## SAFETY RECALL CODE 0807 - 1997/1998 FRONT BRAKE ROTOR DRIVE PINS

Buell has determined that the drive pin(s) used on the front brake rotor could move out of position and come in contact with the front brake caliper. This condition could prevent the front wheel from rotating. This could occur without prior warning.

Figure 1. Drive Pin Assembly

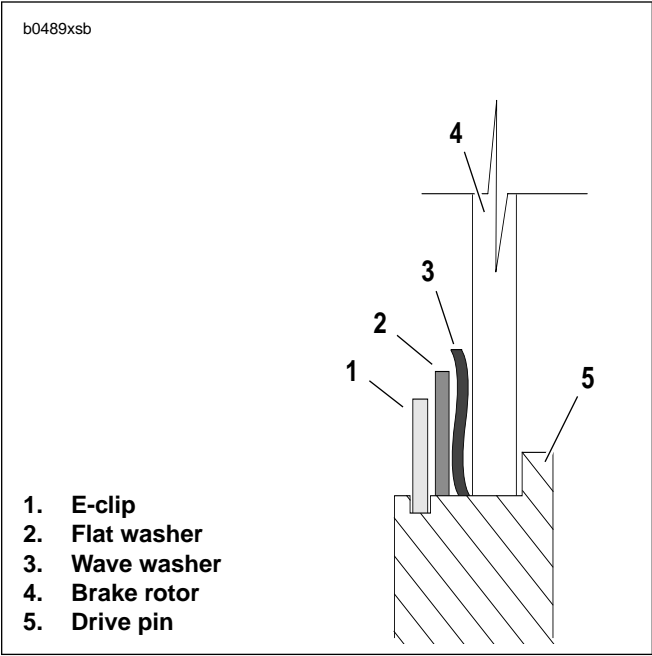
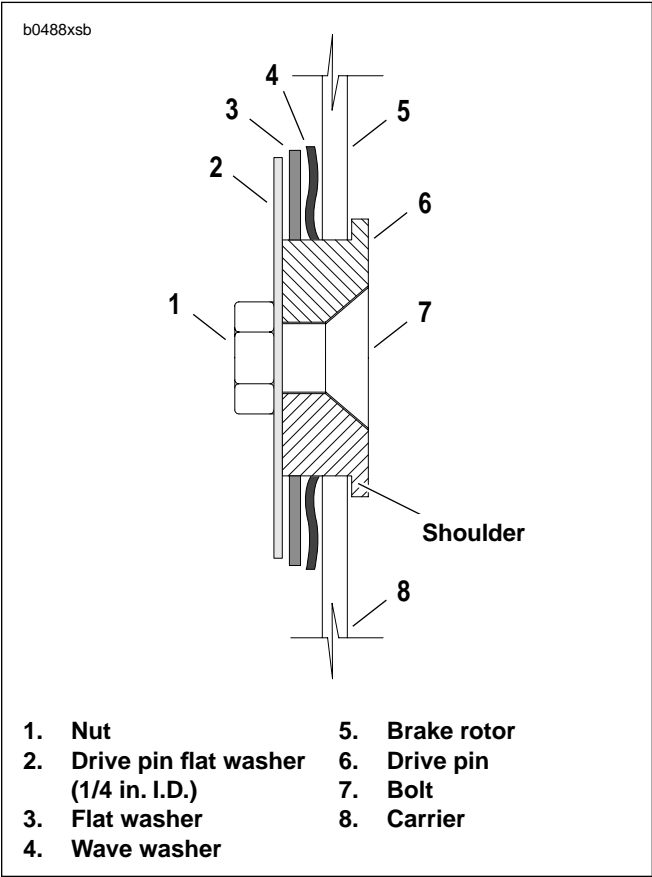
2. See [Figure 1](#). Remove existing drive pin assemblies two at a time.
  - a. Gently pry E-clip (1) away from drive pin (5).
  - b. Completely remove E-clip using a thin bladed screwdriver. Discard E-clip.
  - c. Remove and discard flat washer (2), wave washer (3) and drive pin (5).
3. See [Figure 2](#). Install **new** drive pin hardware through rotor (5) and carrier (8).
  - a. Place drive pin (6) between rotor and carrier. Shoulder on drive pin faces away from wheel hub.
  - b. Insert bolt (7) through drive pin (6).
  - c. Install wave washer (4) on back side of rotor.
  - d. Install flat washer (3).
  - e. Install drive pin flat washer (2).

- 4. Check that flat washer (3) has not fallen between drive pin (6) and drive pin flat washer (2). Install nut (1).
  - a. On cast wheels, torque nut (1) to 7.5-10 ft-lbs (10.2-13.6 Nm).
  - b. On aluminum PM wheels, tighten nut (1) until flush to drive pin flat washer (2). Then turn an additional 60 degrees (one flat on nut).
5. Repeat Steps 1-4 until all drive pin assemblies have been updated.
6. Inspect each drive pin assembly. There must be a minimum clearance of 0.050 in. (1.27 mm) between drive pin assembly and caliper mount bolts.
